October 29, 1985
ST-HL-AE-1487
File No.: G9.17

South Texas Project
Units 1 and 2
Docket Nos. STN 50-498, STN 50-499
Responses to DSER/FSAR Items Regarding Question 430.16N

Question 430.16N

ONSITE DISTRIBUTION SYSTEM CRITICAL PATH COORDINATION - PHASE TIME CURRENT (SH. 1 OF 2)

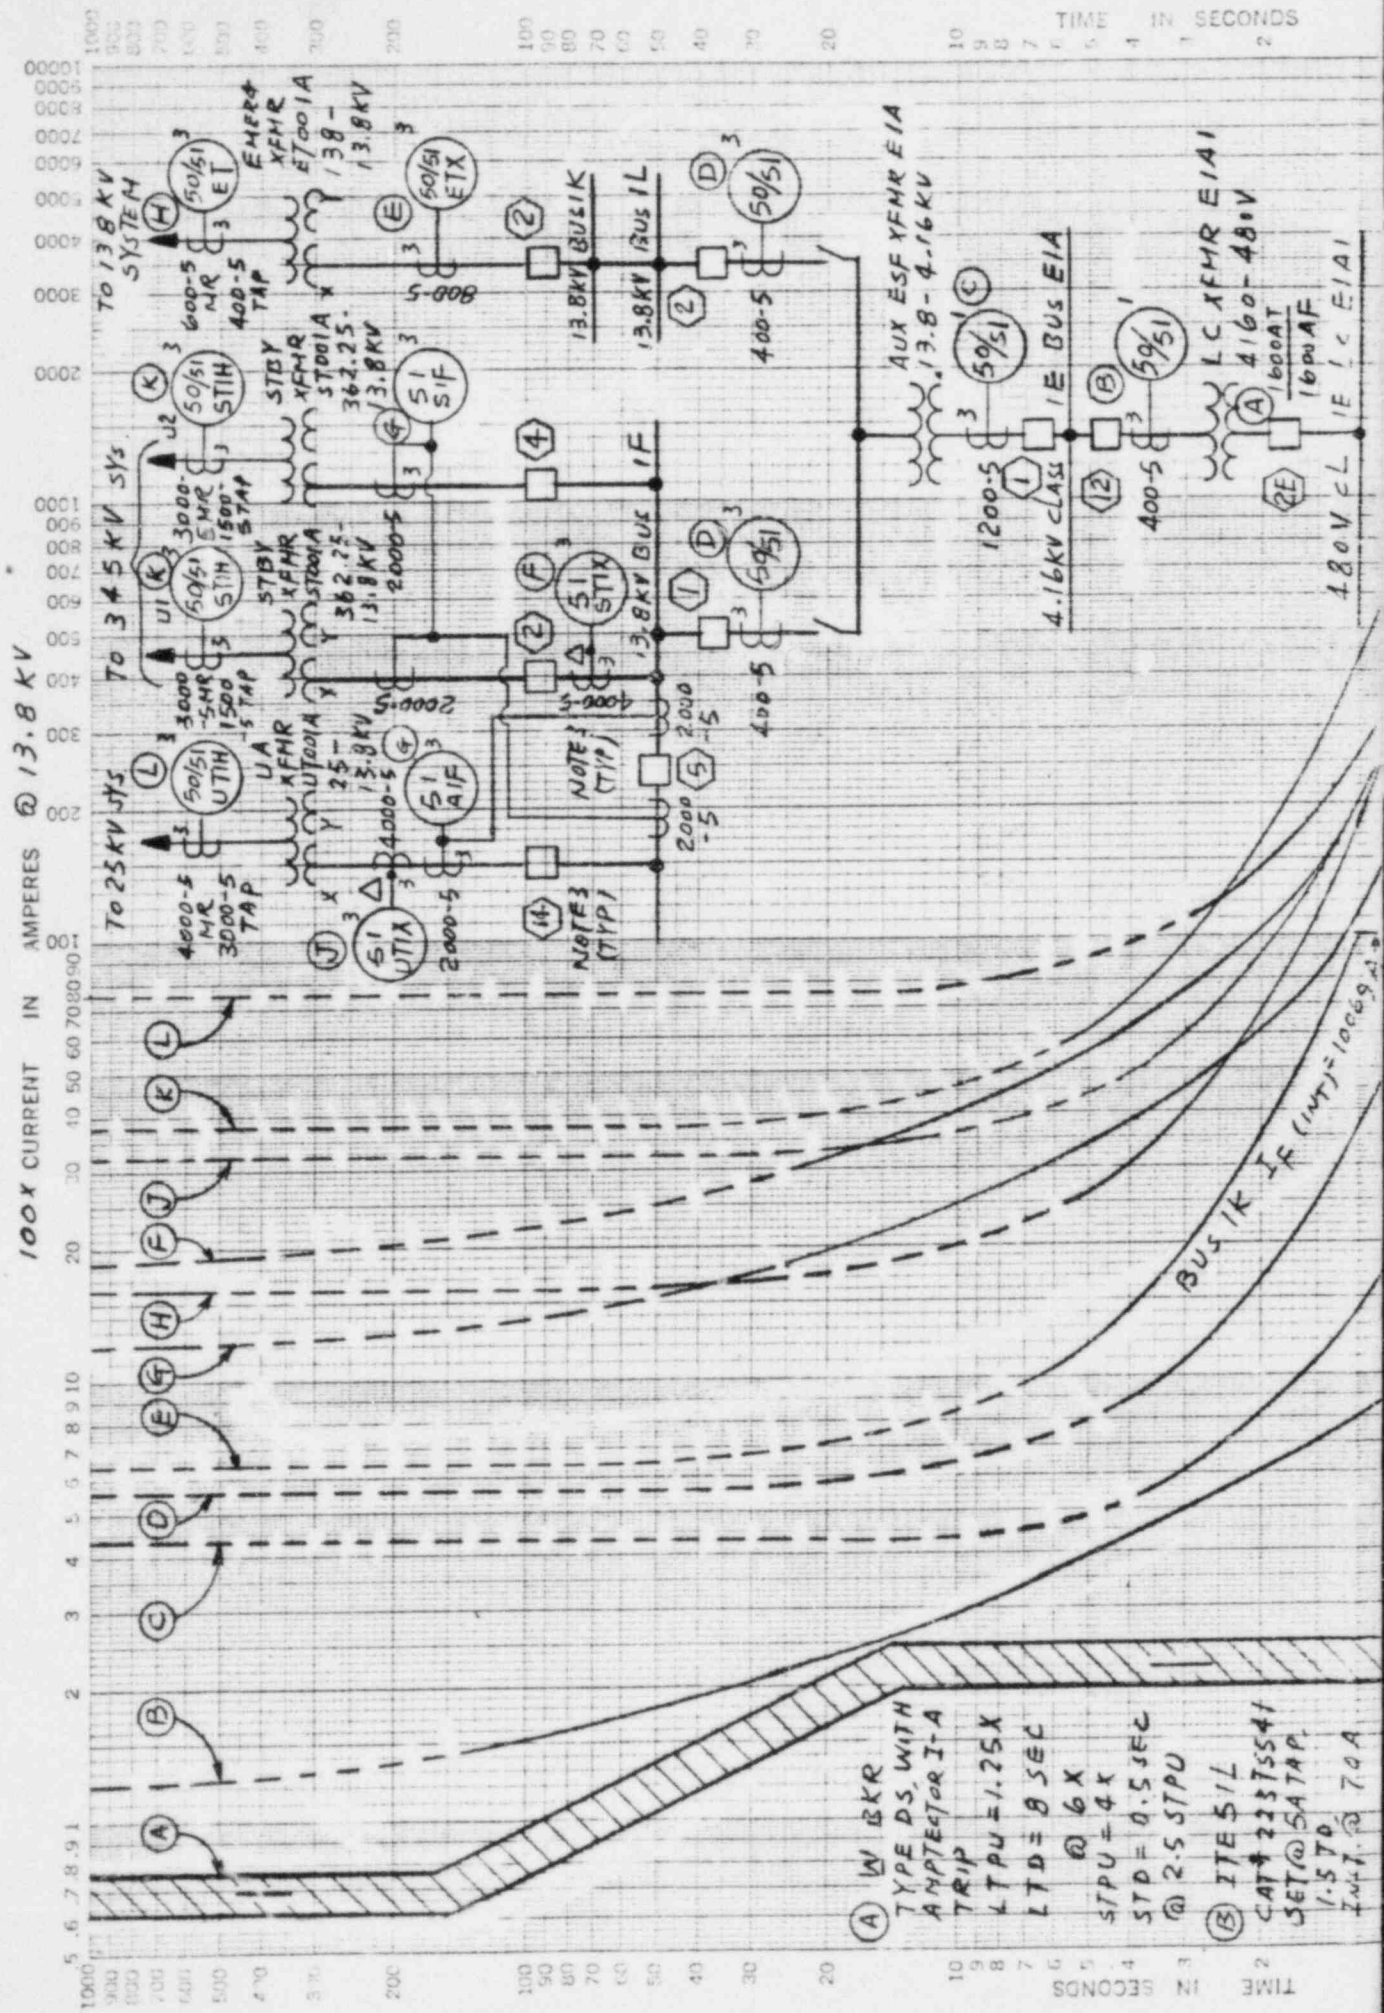
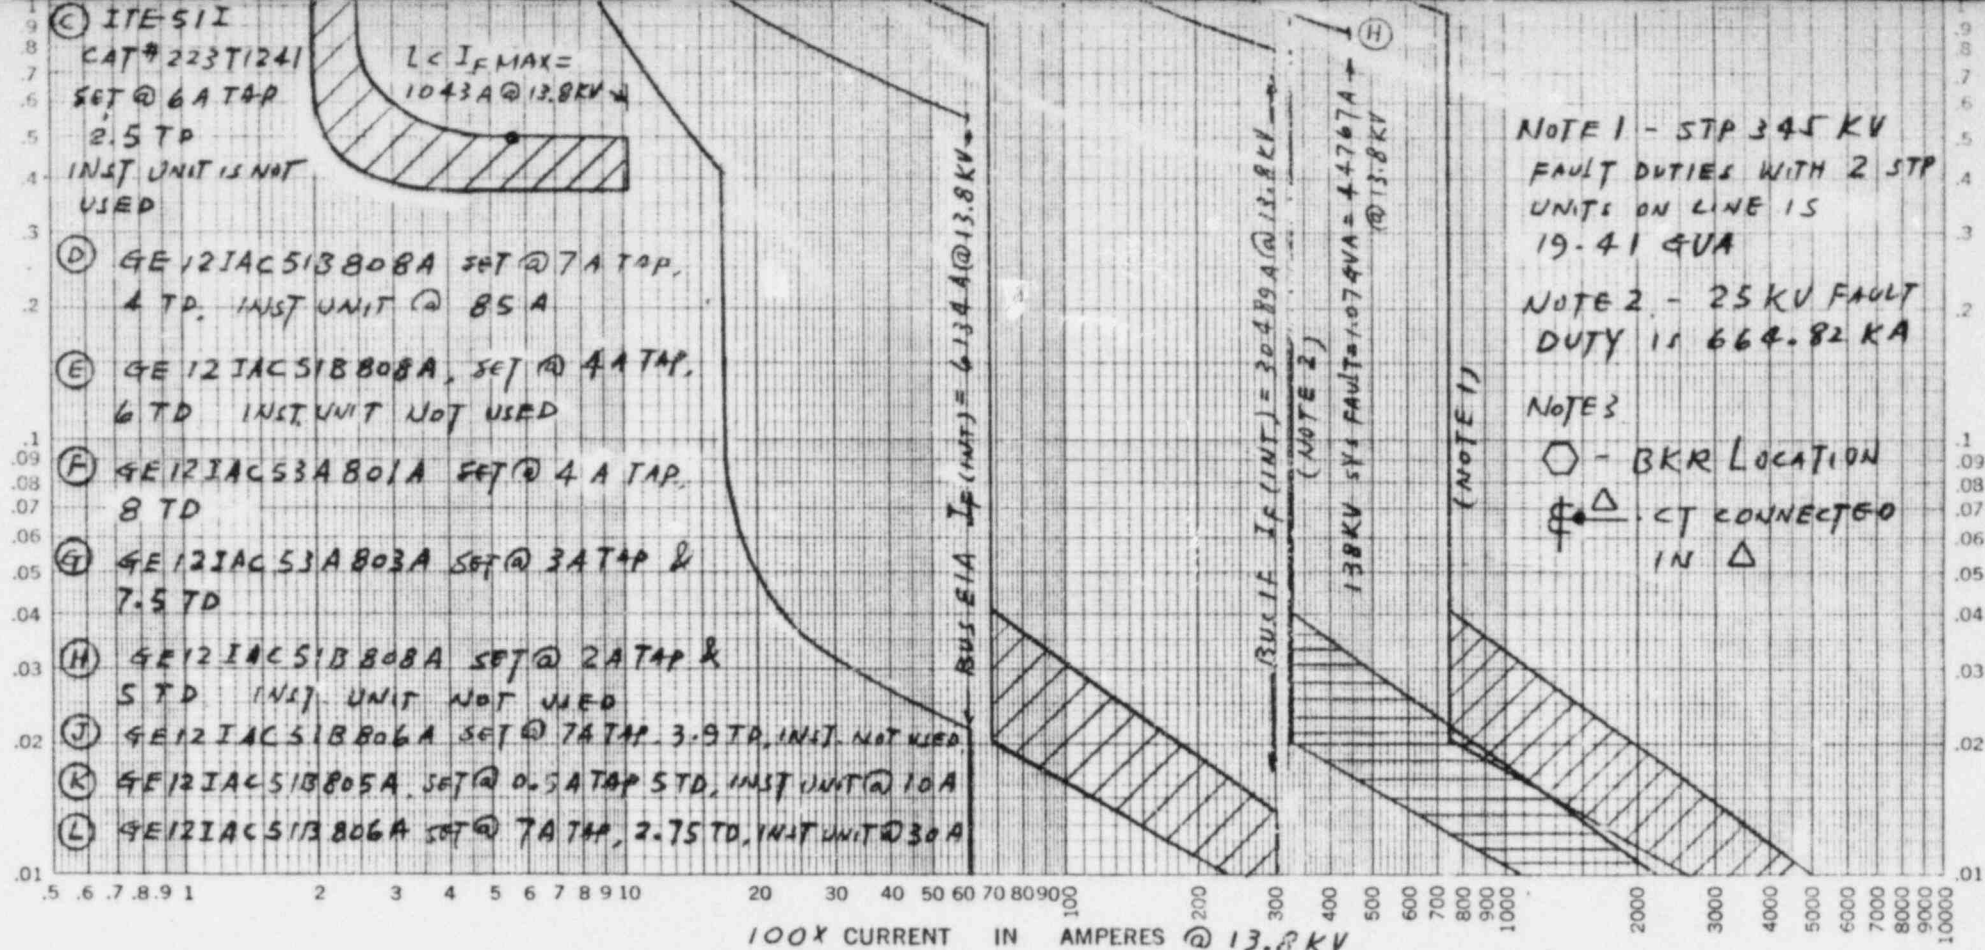
In section 8.3.1 you discuss the onsite distribution system. Your discussion provides insufficient detail for evaluation. Specifically address breaker coordination and the interrupting capacities of switchgear, load centers, motor control centers, and distribution panels under maximum short circuit conditions. Provide this information including supporting drawings and amend your FSAR accordingly.

Interrupting capacities of 13.8 kV and 4.16 kV switchgear are provided in Sections 8.3.1.1.1 and 8.3.1.1.4.1, respectively. Interrupting capacities of 480 V switchgear are selected appropriately, based on the fault current contribution from loads and the source at a bus. Criteria for breaker coordination for onsite power system is discussed in Section 8.3.1.1.4.6. The 13.8 kV and the 4.16 kV detailed design documents are presently available for review. The 480 V detailed design documents will be available after the third quarter of 1985.

Maximum short circuit conditions have been calculated conservatively, by assuming the ultimate system contribution of 30 GVA (the system contribution with the two STP units on line, and with the eight transmission circuits will be 19.41 GVA) and maximum load fault current contribution (motors ≥ 50 HP and with standby diesel generator during testing). The calculations will be updated with final data.

The present calculations indicate that the interrupting capacities of the equipment identified below is not exceeded under worst-case short circuit conditions, with the exception of two out of four 13.8 kV switchgear which yield a negligible, yet negative interrupting capacity margin of 0.2 percent. The present calculations are acceptable

The drawings with breaker coordination curves are being submitted by separate cover letter (see ST-HL-AE-1387 dated 10/24/85).
